63A

.....  
August 20, 2007

**APPROVAL** of a request from West Lakes Properties, LC (owner) represented by Gerard Neugent (officer) to amend the Des Moines 2020 Community Character Plan from Low Density Residential and undesignated to Commercial: Auto-Oriented Small Scale-Strip Development, Low Density Residential, Low/Medium Density Residential and Park/Open Space for property located in the vicinity of 300 County Line Road as more specifically shown on the accompanying map. (21-2006-4.22)

CITY PLAN AND ZONING COMMISSION  
ARMORY BUILDING  
602 ROBERT D. RAY DRIVE  
DES MOINES, IOWA 50309-1881  
(515) 283-4182

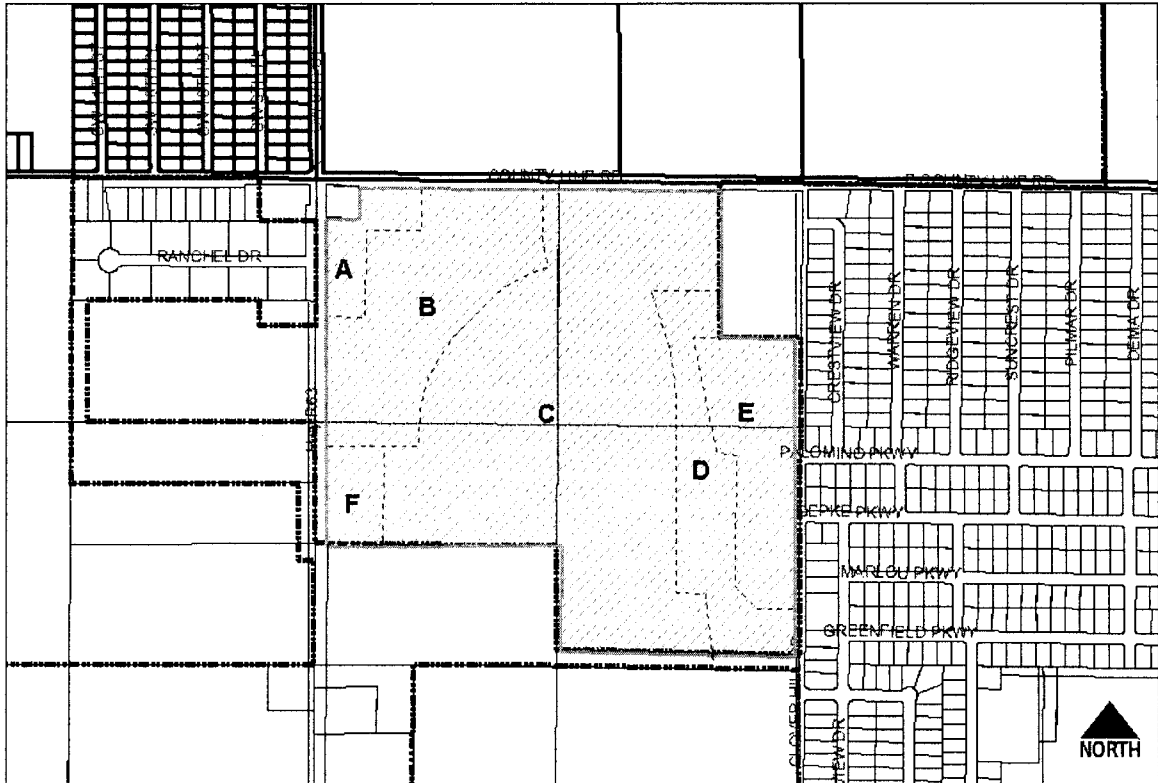
A From: Low-Density Residential  
 To: Commercial: Auto-Oriented  
 Small-Scale Strip Development

B & E From: Low-Density Residential  
 and No Designation  
 To: Medium-Density Residential

C From: Low-Density Residential  
 and No Designation  
 To: Low-Density Residential  
 and No Change

D & F From: Low-Density Residential  
 and No Designation  
 To: Park/Open Space
